No. 396 / POL 9 **1st prolongation**  
**CERTIFICATE OF JUMPING HILL**  
**CERTIFICAT DE CONFORMITE**  
**SCHANZENPROFILBESTÄTIGUNG**

Place: Szczyrk

Name: Skalite 70

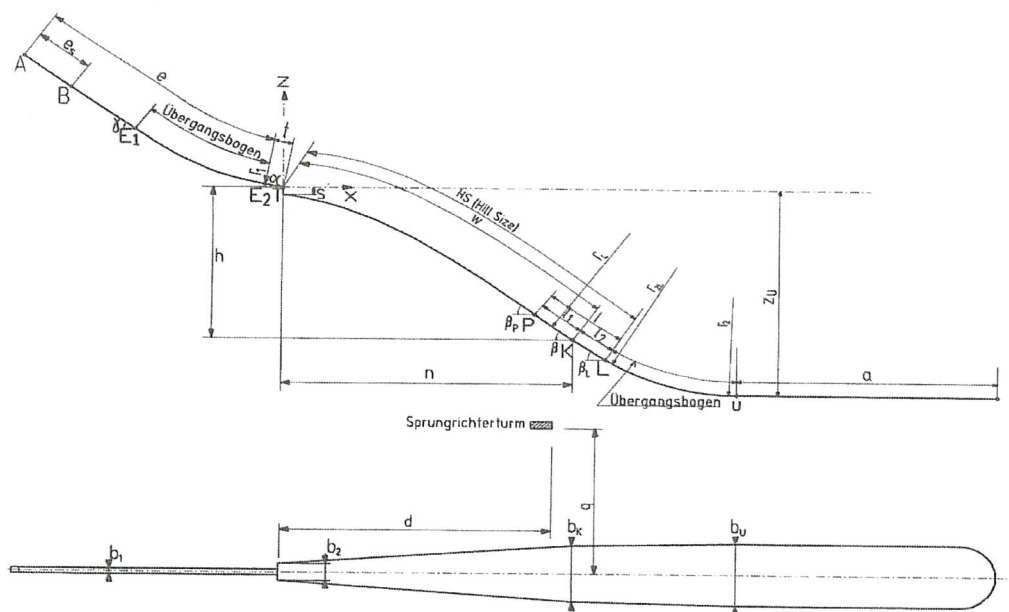
- inspection by Miran Tepes (13th August 2020)
- the remarks of inspection report must be fulfilled for validity of the certificate
- for the standards of the construction of jumping hills (FIS ICR) the owner is responsible during the training and competition
- in recommendation of the inspector Miran Tepes, the HS should be reduced by 2 m, the corrected and red marked numbers have to be observed and changed in the guardrails!
